**Addendum to Technical Drainage Study
Update #1
For
Spanish Villas – Phase 1
(aka: Car Wash @ Sahara & Spanish Oaks)**

Lochsa Job No. 221125

February 2023

Subject: Addendum to Technical Drainage Study Update for Carwash West Sahara
APN: 162-05-403-001
DS5634A
(Lochsa Engineering Project No. 221125)

Street Section 1 - Spanish Oaks Drive - Developed Condition - 10year Cross Section for Irregular Channel

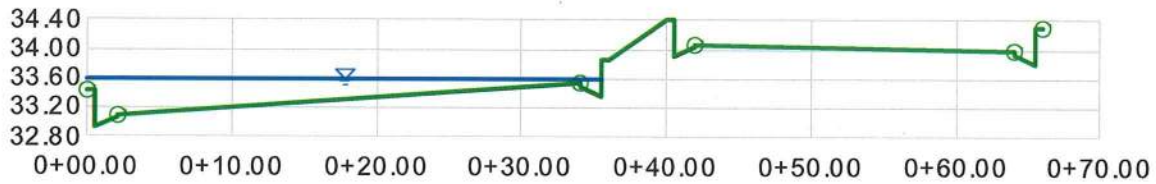
4. The finished floors do not meet the Regional Flood Control District minimum criteria of twice the Q100 depth of flow up to 18-inches above the water surface (CCRFCD Manual Section 304.4.E.1) or 6-inch minimum above the highest adjacent top of curb (CCRFCD Manual Section 1602 304.4.E.1). Provide a flood wall in the landscape area adjacent to Spanish Oaks Drive or equivalent adequate flood protection for the building.

COMMENT #4

Response 4: Noted. Per Comment 5 below, we revised the offsite basin FD1 which increased flow. The revised 100yr depth of flow is now 0.79ft (previously 0.75ft) in Spanish Oaks Drive.

With this in mind, we have proposed a 2 course solid grouted wall at back of sidewalk to protect the site from offsite flows along Spanish Oaks Drive. This provides an additional 16-inches plus the curb height (6-inches) from the Flowline elevation in the street, which is more than twice the 100yr flow depth.

The FF elevation of the Car Wash does meet criteria for Sahara Avenue flows so no wall is needed here. However, we have provided a wall at back of sidewalk along our Site to convey the flow within the ROW and prevent the flow from getting into our landscaping and eroding the area. See revised Plans. Also the revised Spanish Oaks Drive hydraulic street section has been included with the revised FD1 flows.

OFFSITE BASIN MAP
(DEVELOPED CONDITION)

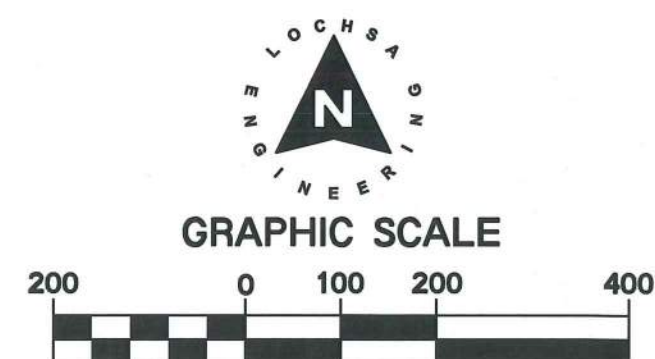
5. A recent site visit and contours indicate more flow approaching El Camino Avenue and Spanish Oaks Drive than offsite basin FD1 presumes. Provide either the reference material or justification for the delineation of the offsite basin, FD1.

Response 5: Per our discussion over the phone on January 18, 2023, it was noted that an additional 3 acres should be added to the offsite FD1 basin. Therefore, we have revised our offsite basin and exhibit OFF to represent the revised FD1 basin. We have provided revised hydrology with a new Developed Condition HEC-1 Analysis showing the revised flows from offsite basin FD1. Offsite basin FD1 now discharges 29 and 53cfs in the 10yr and 100yr storm events. Please note that there are 4 separate drop inlets within El Camino Avenue that we have ignored which would reduce the flow in Spanish Oaks. However, we have chosen to assume they are 100% clogged to be conservative with the design of our Site. See revised Hydrology and the necessary exhibits with the changes.
